Trailside Vacation

**Office of Planning and
Community Development
Seattle City Hall**
600 4th Avenue, 5th Floor
Seattle, WA 98124

March 1, 2018

Public Benefit

Figure 3: Burke-Gilman Trail connection

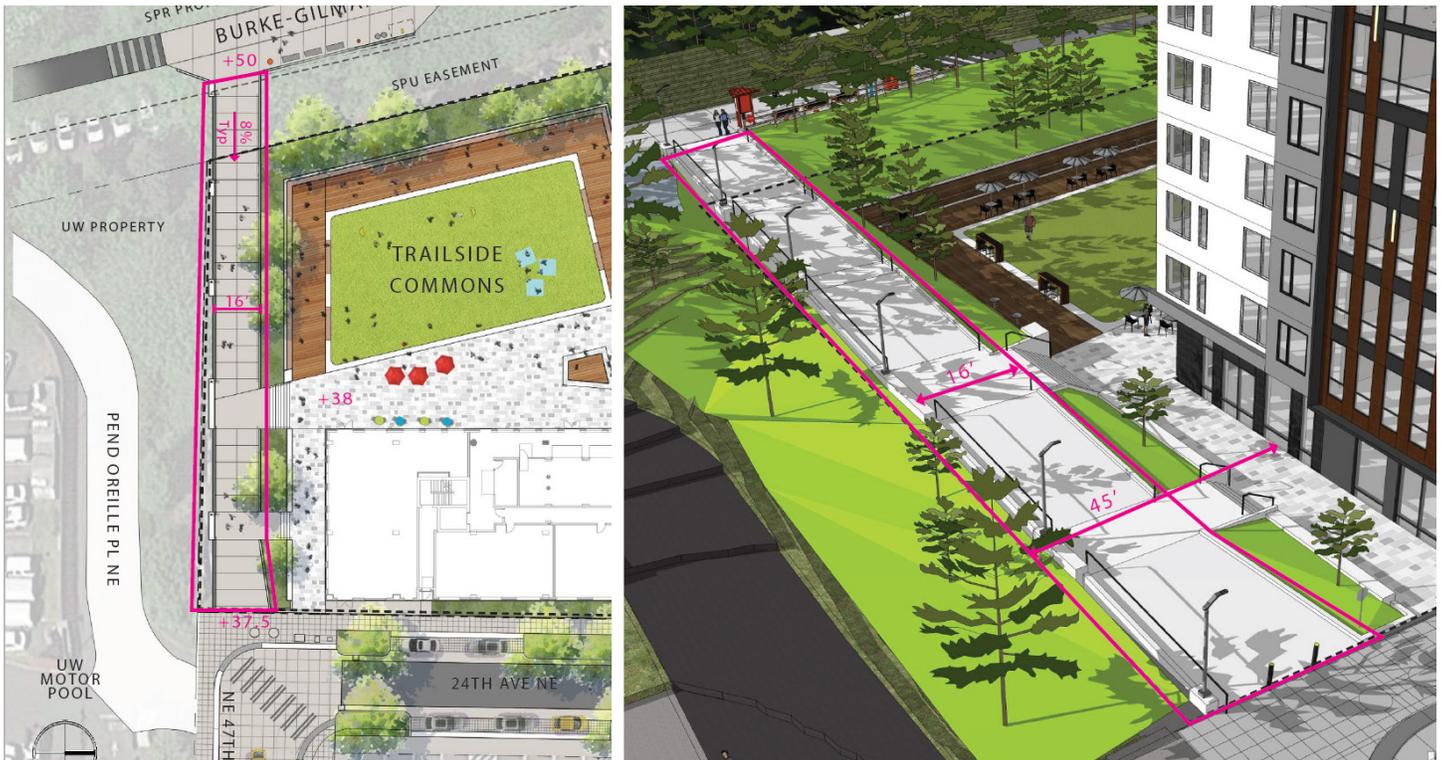
Prior to discussing the proposed element, the SDC strongly recommended the project team rename the element as “Enhanced Burke-Gilman Trail connection” so to not mistake it for the basic connection, which is a part of the urban design merit proposal. Commissioners then agreed the proposed element provided significant improvements above what would be required under any improved connection under the no-vacation alternative, and therefore should be considered as a public benefit. The Commission then discussed the width of the proposed connection. Commissioners thought the proposed 16 ft. wide connection was adequate and would provide for a lot of flexibility in the future. The SDC then discussed potential conflicts as cyclists approach the intersection of 24th Ave NE and NE 47th St. Commissioners thought the inclusion of bollards would help in reducing conflicts and recommended the project coordinate with SDOT to understand the appropriate spacing for bollards to reduce cyclist speed. The Commission also recommended providing low ambient levels for pedestrian lighting along the connection to assist in the transition from NE 47th St, which is lighted, to the Burke-Gilman Trail, which is not lighted.

The SDC recommended the project team provide an update about the design and width of the trail connection to SDC staff at 90% design; if there are significant changes the SDC may require the updated design return for a subcommittee review.

3. Pay special attention to spacing of bollards at the entrance to the trail connection at NE 47th and 24th AVE NE to reduce cyclist speed.
4. Consider providing low ambient levels for pedestrian lighting to assist in the transition from NE 47th St, which is lighted, to the Burke-Gilman Trail, which is not lighted.

5. Provide an update about the design and width of the trail connection to SDC staff at 90% design; if there are significant changes the SDC may require the updated design return for a subcommittee review.

Figure 4: 24th Ave NE ROW improvements

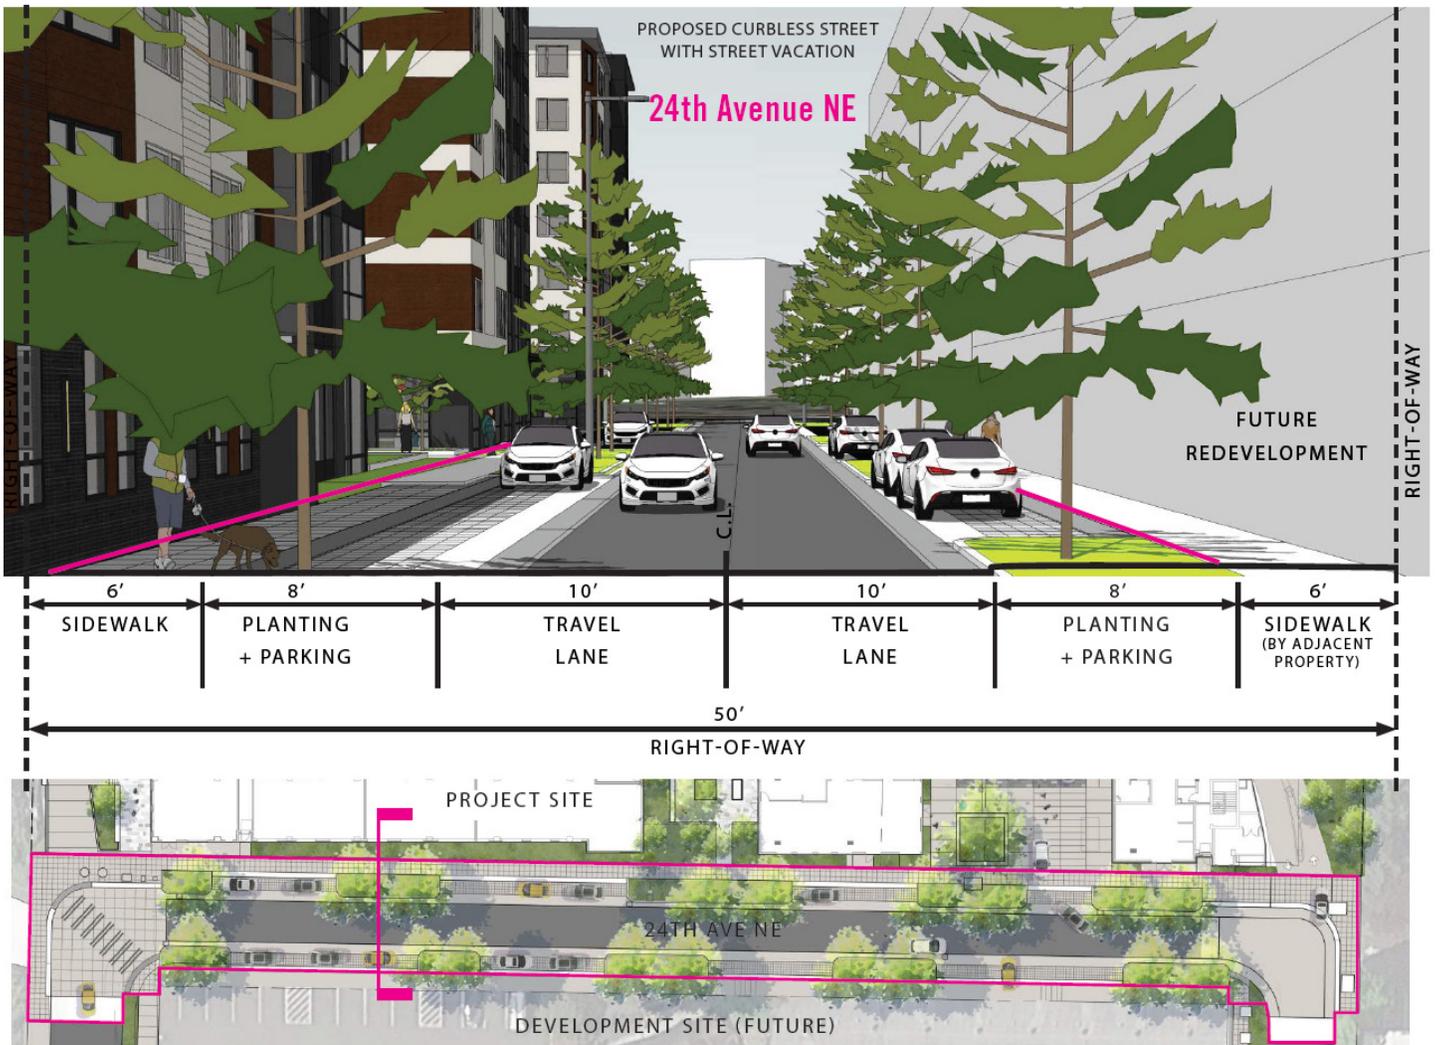
The SDC discussed the enhanced ROW improvements along 24th Ave NE followed by discussing the improvements along NE 47th St. The Commission commended the project team for the proposed ROW improvements along 24th Ave NE. Commissioners then discussed alternatives to the proposed solid crosswalk striping at the 24th Ave NE and NE 47th St. intersection. The Commission provided examples of alternatives that would provide a visual cue to drivers that they are entering a pedestrian area. The SDC recommended the project team continue to work with SDOT on the design of the intersection, paying close attention to materials and pavement treatments to prioritize pedestrian movement.

6. Continue to work with SDOT on the design of the pedestrian crossing at the 25th Ave NE and NE 47th St intersection; pay attention to materials and pavement treatment to prioritize pedestrian movement.

Figure 5: NE 47th St. ROW improvements

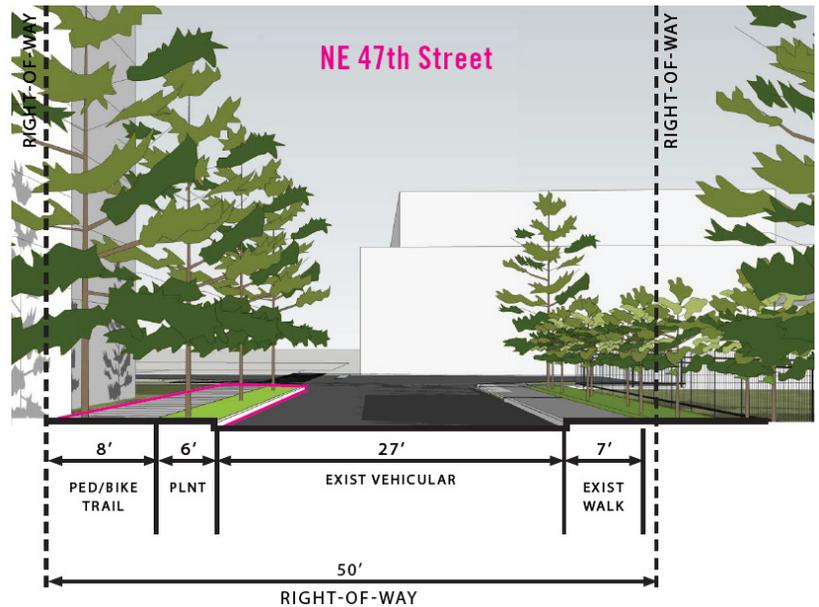
The SDC then discussed the enhanced ROW improvements along NE 47th St. Commissioners recommended the project team reduce the curb radius at the 25th Ave NE and NE 47th St to reduce vehicular speed. The Commission then had several concerns with the mixed-use pathway along the northside of NE 47th St. Commissioners are concerned the proposed mixed-use pathway is not wide enough to handle two-way traffic for both pedestrians and cyclists. The SDC recognized this street as part of a bicycle corridor between the Burke-Gilman Trail and U-Village and recommended the project team work with SDOT to create an appropriate design to facilitate the safe movement of cyclists and pedestrians along NE 47th St.

7. If possible, consider reducing the curb radius at the intersection of 25th Ave NE and NE 47th St.
8. Continue to work with SDOT to create an appropriate design to facilitate the safe movement of cyclists and pedestrians along NE 47th St between 24th and 25th Avenues.

Figure 7: Wayfinding signage locations

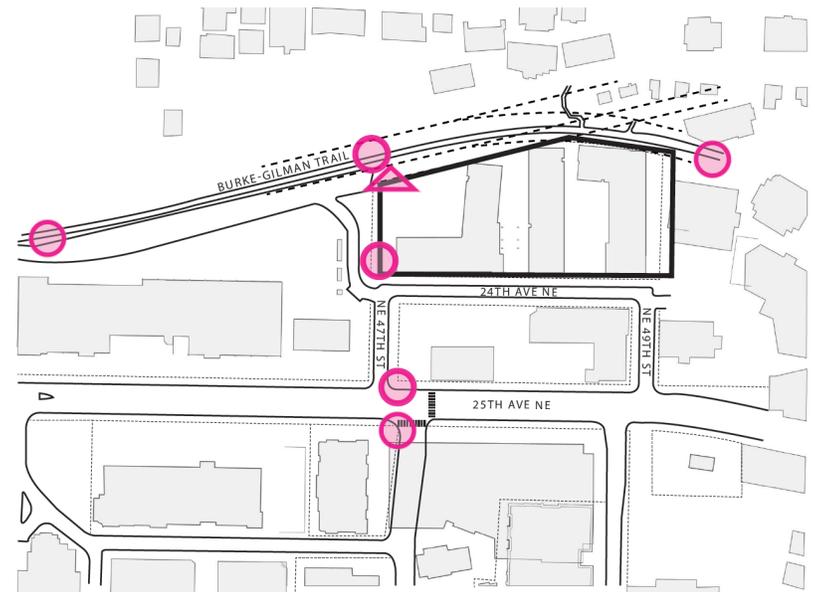
The SDC recommended the project team provide a range for the number of wayfinding signs they are proposing rather than stating a specific number. The Commission then recommended the project team continue to work with SDOT and SPR on the design and information provided on the proposed wayfinding signs and kiosk.

9. Continue to work with SDOT to calculate the percentage of proposed landscape area that should be considered as public benefit.
10. Provide a range for the number of wayfinding signs they are proposing rather than stating a specific number.

11. Continue to work with SDOT and SPR on the design and information provided on the proposed wayfinding signs and kiosk.
